DATE: November 30, 2012

ADDENDUM NO. 1

JAMES CITY COUNTY
INVITATION FOR BID #12-5103
Rehabilitation of LS 1-5, Chisel Run Interceptor

Correction to Sheet C-3

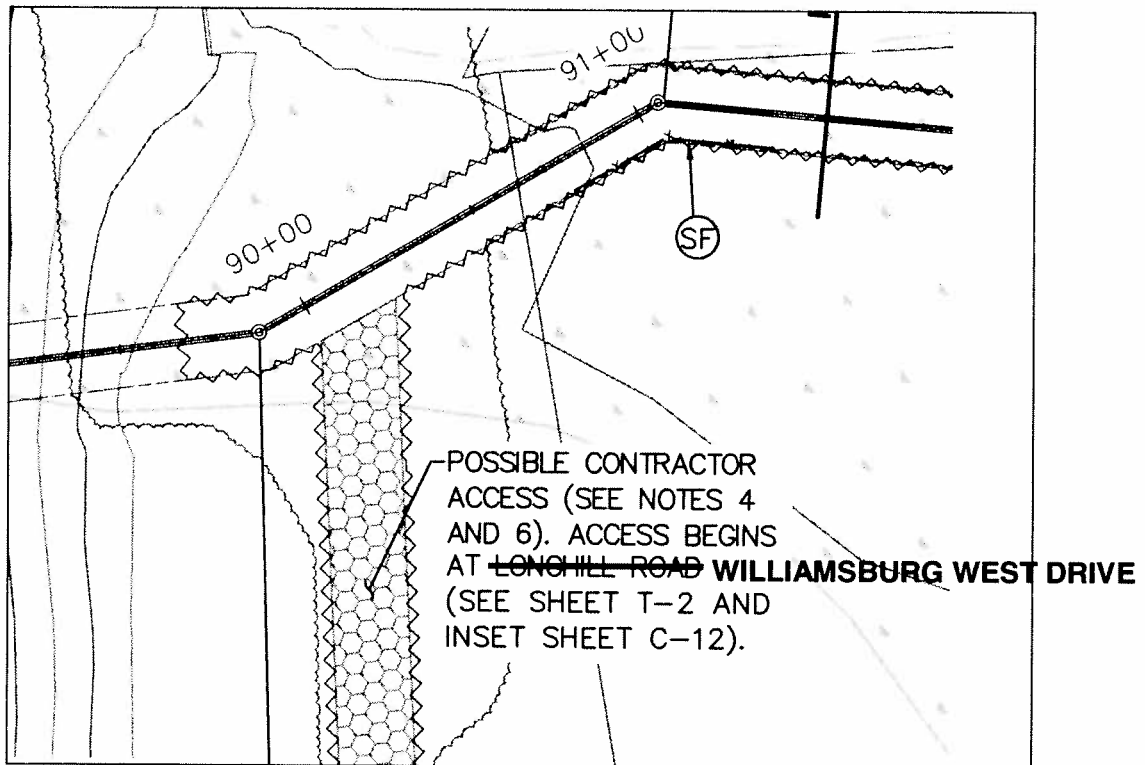
- The project is in an environmentally sensitive area, hence the extensive requirement for silt fence in disturbed areas to protect creeks/swamps from siltation anywhere that land surface is disturbed.
- The County is concerned about safety of the curious public. Any excavation left open at the end of the workday must be protected by safety fence, which may be removed at the start of the next workday.
- Bypass pumping would be in accordance with the Regional Construction Standards, which were modified in Section 110 to specify flow rates up to 4 rather than 2 mgd.
- JCSA stated that the project is generally in a wooded setting and out of traffic, in contrast to a typical CIPP job in a residential or developed neighborhood.
- Corrections to one call-out and two typographical errors on the plan sheets are shown below.
